Federal Emergency Management Agency

Community: City of Albuquerque,
Bernalillo County,
New Mexico
Map Panel Number: 350002 0010 C
Effective Date of
this Revision: APR 4 1988

REVISED TO
REFLECT LOMR
DATED APR 4 1988

RE: Letter of Map Revision for Domingo Baca Floodplain

PANEL 10 OF 50

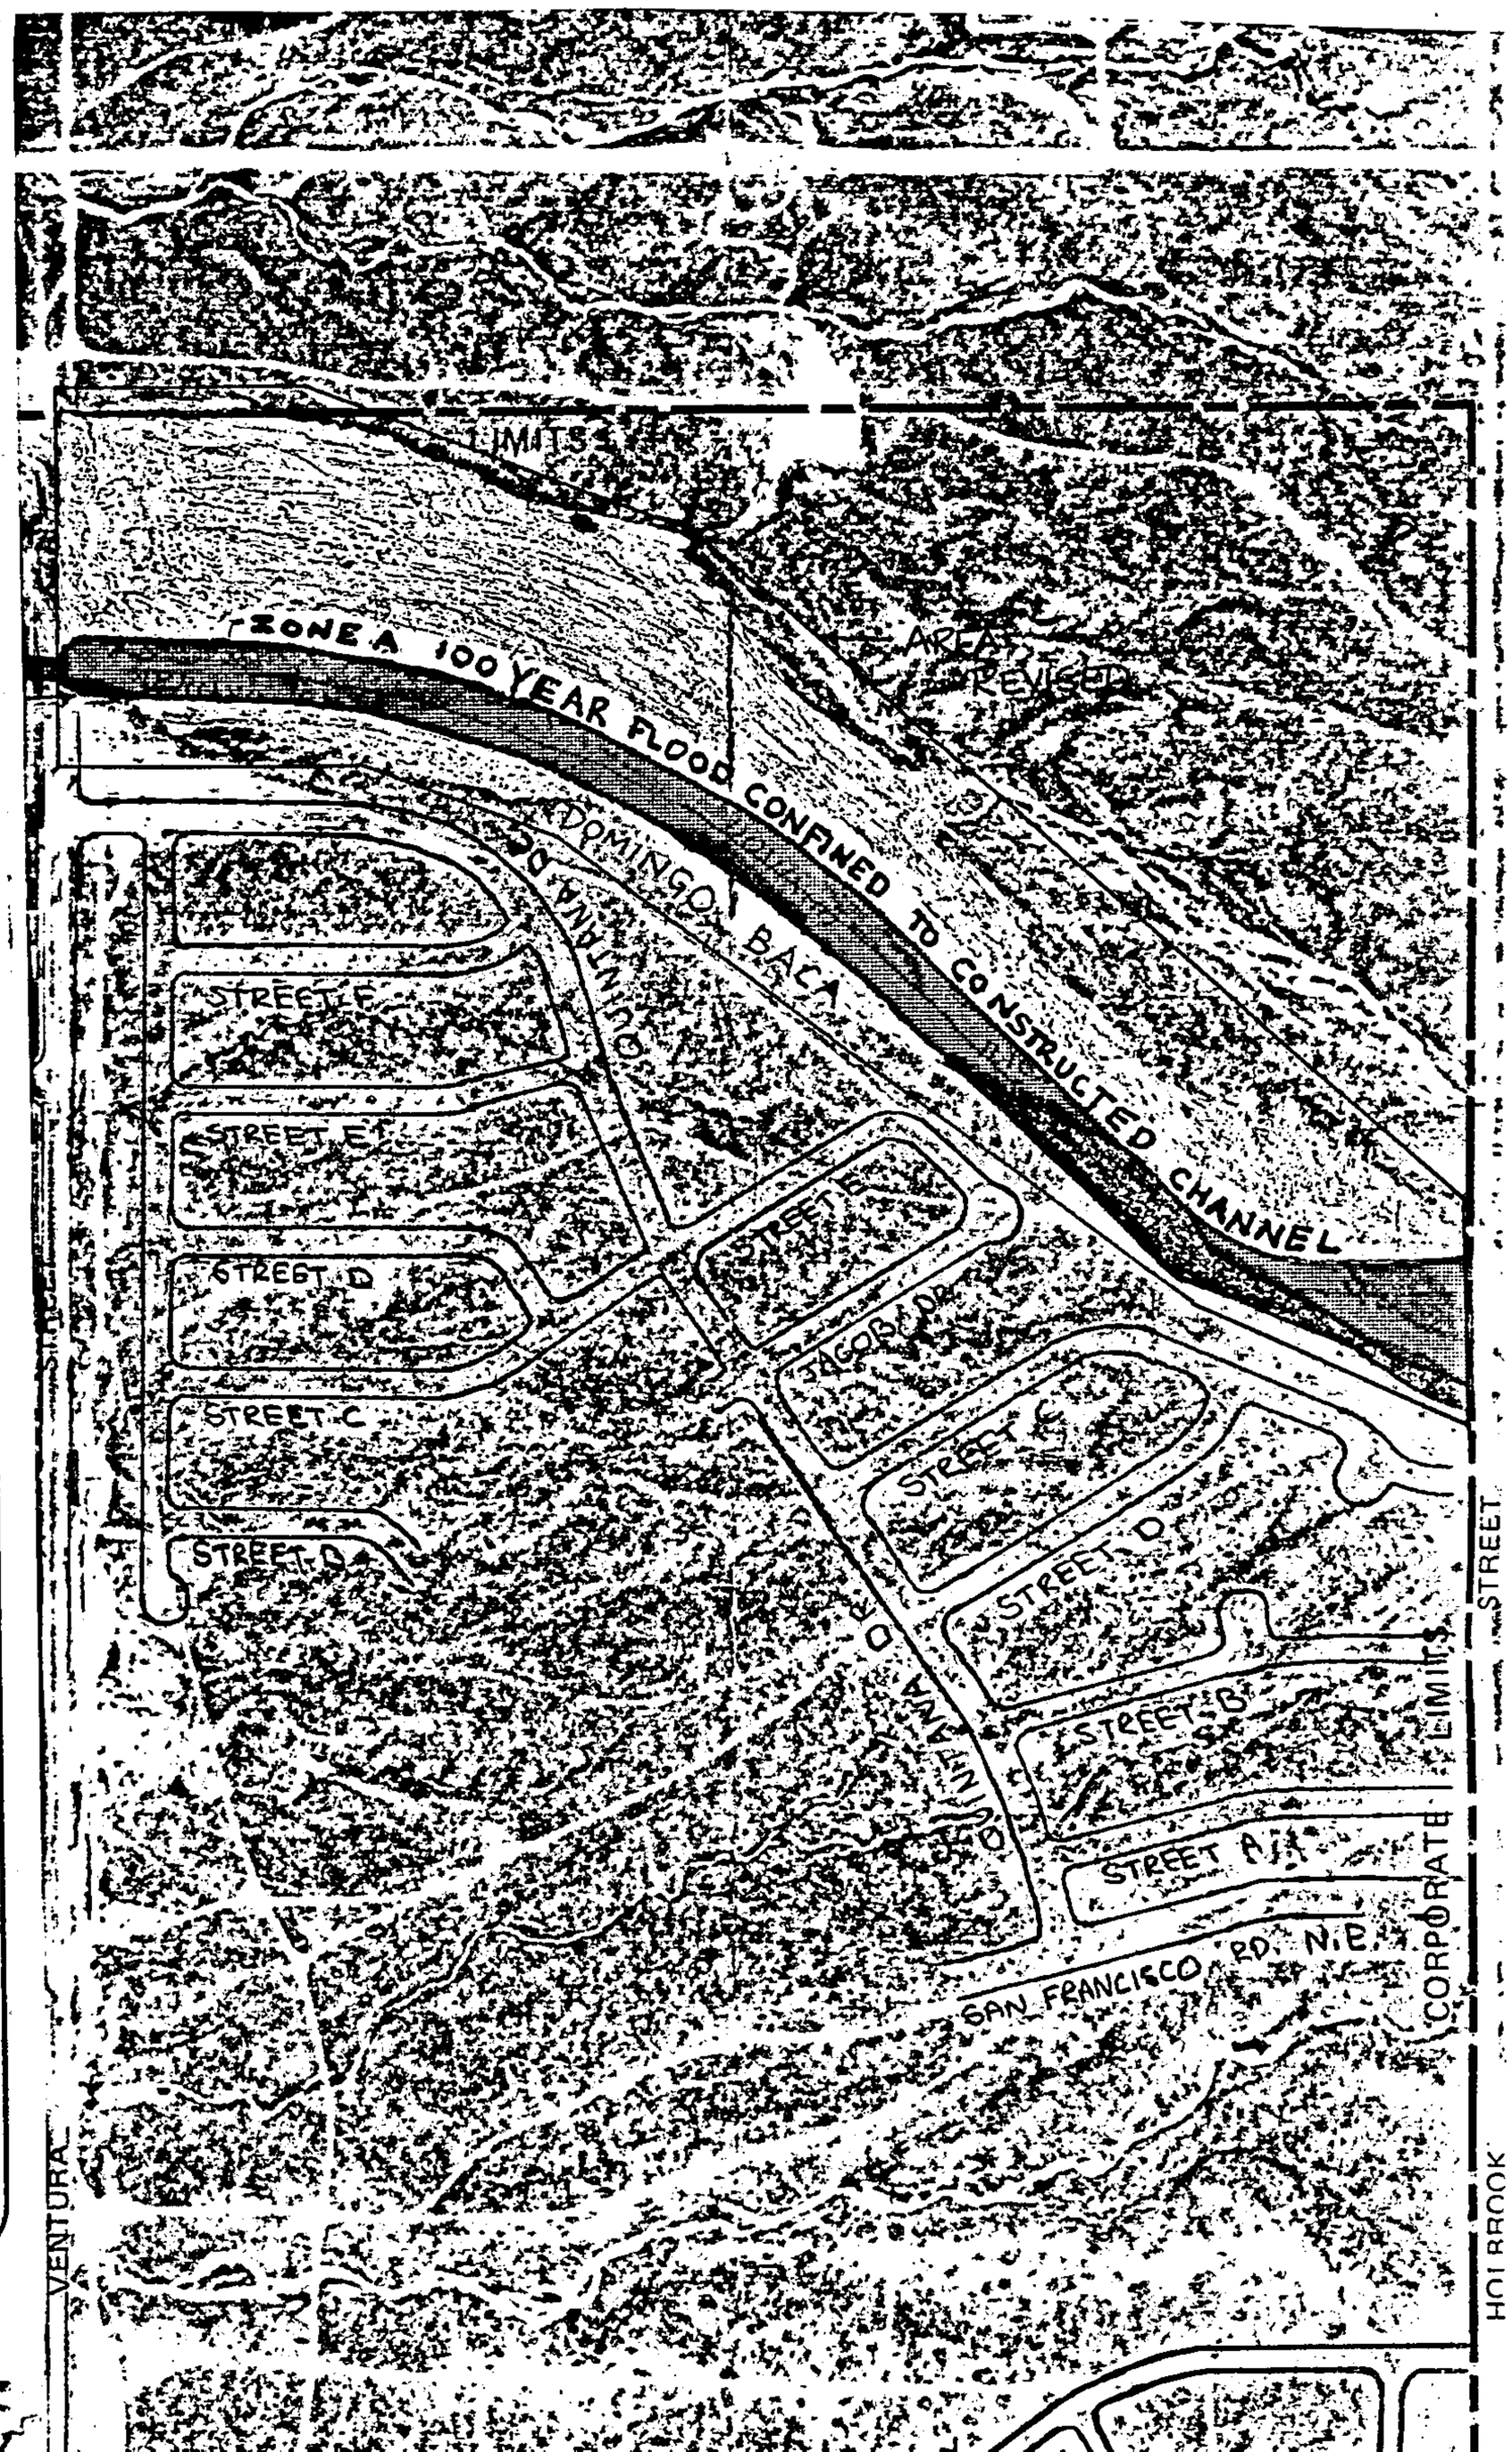
Based on these data, we have revised the Flood Insurance Rate Map (FIRM) to reflect the effects of the completed channelization project, which runs from the City of Albuquerque corporate limits to an existing concrete lined channel at Ventura Street, a total distance of approximately 3,000 feet. The 100-year floodplain boundary has been changed from Zone AO to Zone A and is now contained within the constructed channel as depicted on the enclosed annotated portion of the FIRM. This LOMR amends FIRM number 350002, panel 0010 C, dated October 14, 1983, for the City of Albuquerque, New Mexico. Because no regulatory floodways are delineated for Domingo Baca Arroyo, the Flood Boundary and Floodway Map will not be revised.
